Access Compliance Report

Public Rights-of-Way

Intersection ID: 52450	Main Street: TRANQUIL_OAK_PL	Cross Street: MOSS_LN	Location: NE
ADA ID: 03BE82AD57CA	Ramp Type: Directional1	Initial Pass/Fail: Fail	Overall Compliance: No
		Severity Score: 12.5

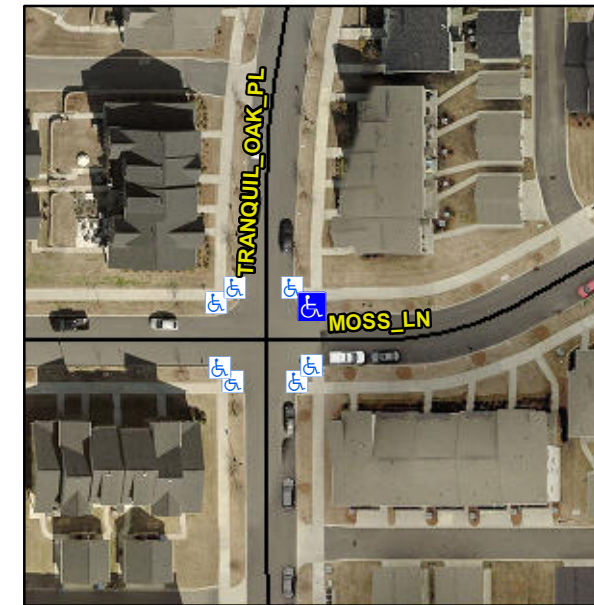
R304.2.2

Compliance	Description	Data	Compliance	Description	Data
N/A	Ramp Length (in)	86.0	N/A	Grade Break?	N/A
Yes	Ramp Width (in)	66.0	N/A	Grade Break Slope (%)	0.0
No	Ramp Slope (%)	9.4	N/A	Grade Break XSlope (%)	0.0
Yes	Ramp XSlope (%)	1.8			
N/A	Flare Type LT	N/A	N/A	Flare Type RT	N/A
N/A	Flare Slope LT (%)	N/A	N/A	Flare Slope RT (%)	0.0
N/A	Flare Traversable LT?	N/A	N/A	Flare Traversable RT?	N/A
N/A	Landing Length (in)	0.0	N/A	DWS Provided?	N/A
N/A	Landing Width (in)	0.0	N/A	DWS Contrast?	N/A
N/A	Landing Slope (%)	0.0	N/A	DWS Length (in)	N/A
N/A	Landing X Slope (%)	0.0	N/A	DWS Full Width?	N/A
N/A	Landing Curb? (Y/N)	N/A	N/A	DWS Offset LT (in)	N/A
N/A	Shared Landing?	N/A	N/A	DWS Offset RT (in)	N/A
N/A	Gutter Ponding?	0.0	N/A	Gutter Slope (%)	N/A
N/A	Gutter Lip Ht (in)	0.0	N/A	Gutter X Slope (%)	N/A
N/A	Painted X Walk1?	No		Road Slope (%)	1.5
	X Walk 1 Direction	To S		Road X Slope (%)	3.9
	X Walk 1 Width (in)	N/A		Clear Space?	N/A

Remove & Replace Entire Ramp.
